Safety Recall Notice

AFFECTED MODEL: The only Giant brand bicycle model affected by this recall is the 2004 model year VT3 model, of which approximately 1380 were sold in the U.S. The recall does not involve any other models of Giant brand bicycles. If you have a Giant VT3 model bicycle, please contact your local authorized Giant retailer or Giant Bicycle at (866) 458-2555. You will need the serial number from your bicycle, which can be found embossed on the bottom of the bicycle where the seat tube intersects with the down tube (the bottom-bracket shell.) A photograph of the 2004 model year VT3 model can be found below:

Figure 1. Quick-release lever with potential for contact Figure 2. Quick-release lever with adequate clearance

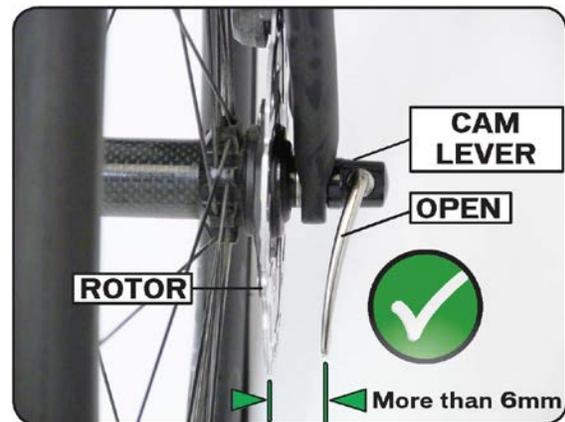
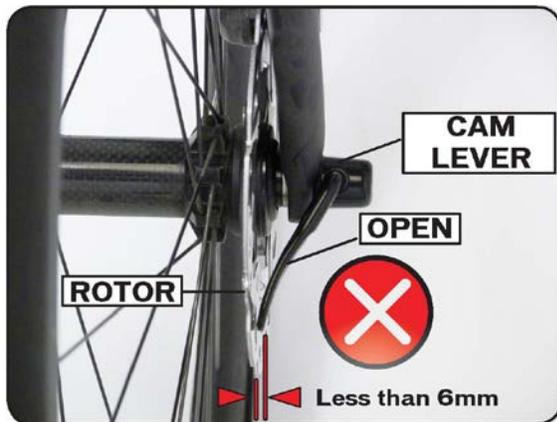
Some Giant brand bicycles were sold equipped with disc brakes and a front quick release lever that can come into contact with the front disc brake when improperly adjusted or left open while riding. An example of a bicycle with a front quick-release cam lever that is able to be opened far enough to create this potential contact is shown in Figure 1 below. An example of a bicycle with a front quick-release cam lever that does not have the potential for contact with the disc brake is shown in Figure 2. When a quick release like the one shown in Figure 1 is improperly adjusted or left open on a bicycle which also has a front disc brake, the quick release lever can become caught in the front disc brake assembly. If this happens, the front wheel could separate or come to a sudden stop and the rider could lose control of the bicycle posing a serious risk of injury.

WHAT GIANT BICYCLE WILL DO FOR OWNERS OF A RECALLED BICYCLE: If you own a Giant brand bicycle that is subject to this recall, Giant Bicycle will provide you—through your local authorized Giant retailer— a free set of front and rear replacement quick releases, including free installation. Please see your local authorized Giant retailer or contact Giant Bicycle with questions at (866) 458-2555.
